UNITED STATES PATENT AND TRADEMARK OFFICE

APPLICATION NO.	FILING DATE	FIRST NAMED INVENTOR	ATTORNEY DOCKET NO.	CONFIRMATION NO.
10/696,216	10/28/2003	Paul T. Wingett	H0004820	7323

Office Action Summary

FIG. 5

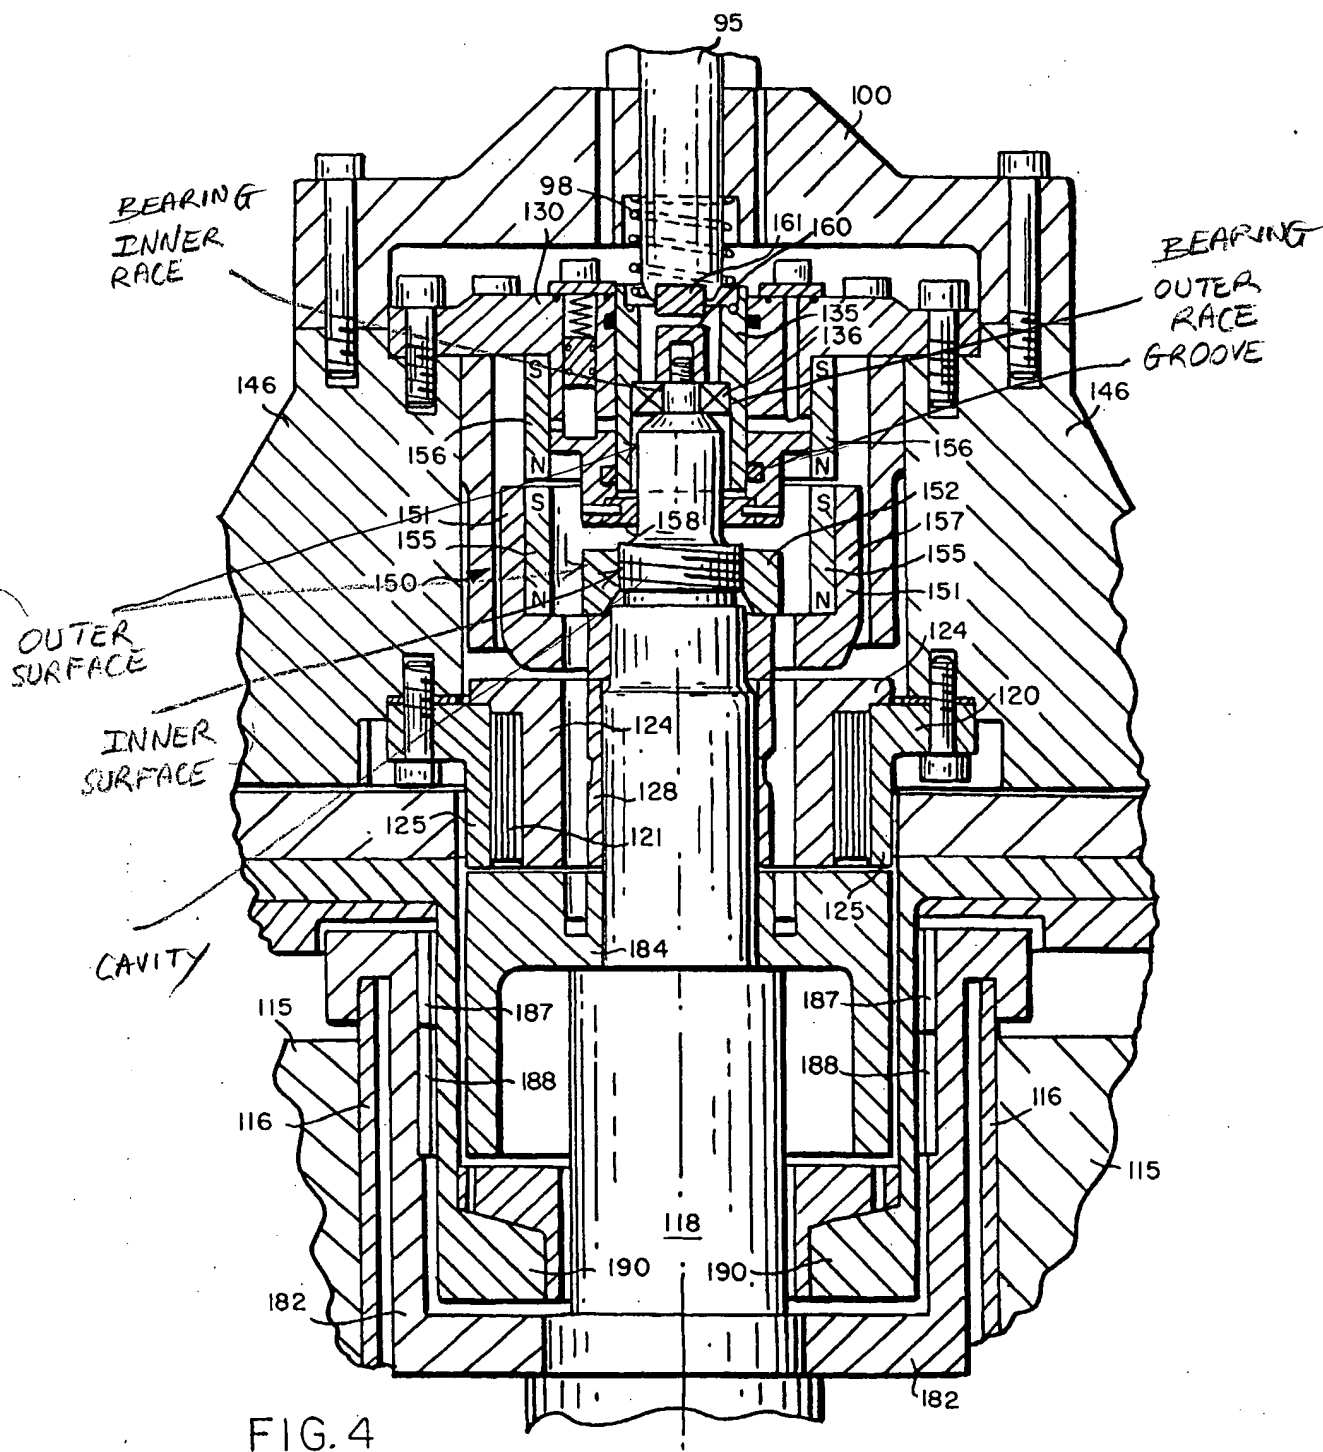
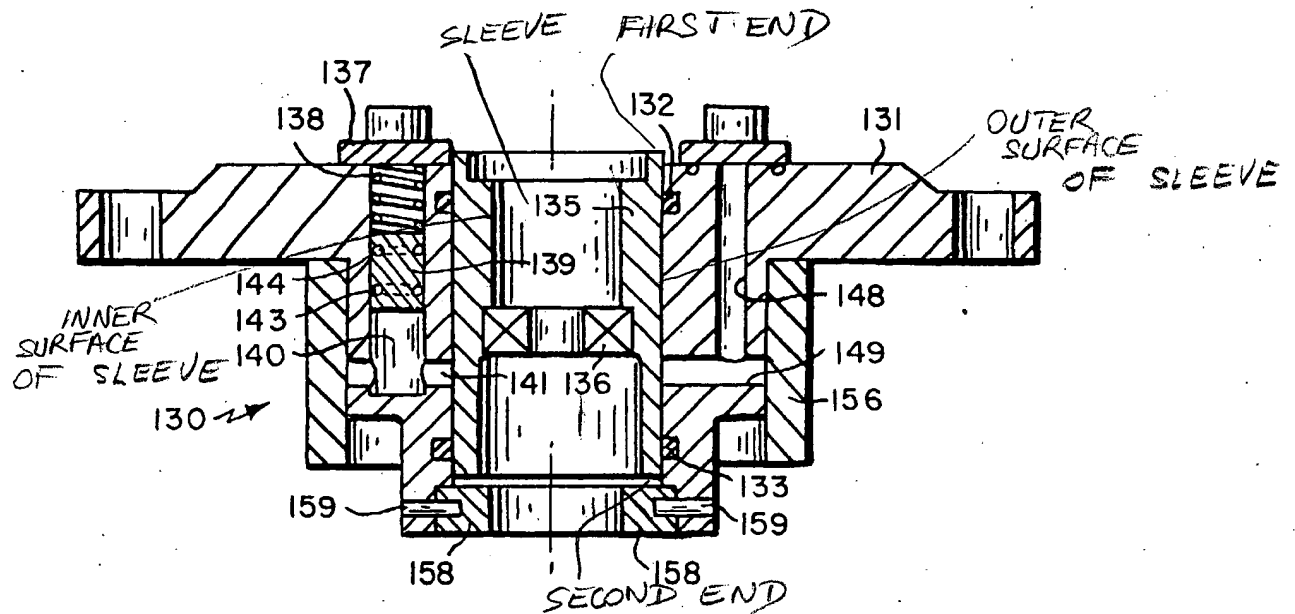
Regarding claim 7, Hockney teaches a bearing assembly (Figs. 4, 5, and 7) for selectively engaging a shaft 118, comprising:

a bearing 136 having at least an inner race and an outer race (unnumbered in Fig.

4. *Ibid.* column 5, lines 11-31. See Attachment or “Att.”);

a sleeve 135 having at least an inner surface (Fig. 5, Att.), an outer surface (Att.), first and second ends (Att.), at least a portion of the sleeve inner surface (Att.) coupled to the bearing outer race (Att.);

one or more resilient seals 132, 133 coupled to the sleeve outer surface (Att.); and

one or more preload springs 98 (Fig.4) coupled to one of the first and second sleeve ends (Att.). See, e.g., column 4, lines 48-61.
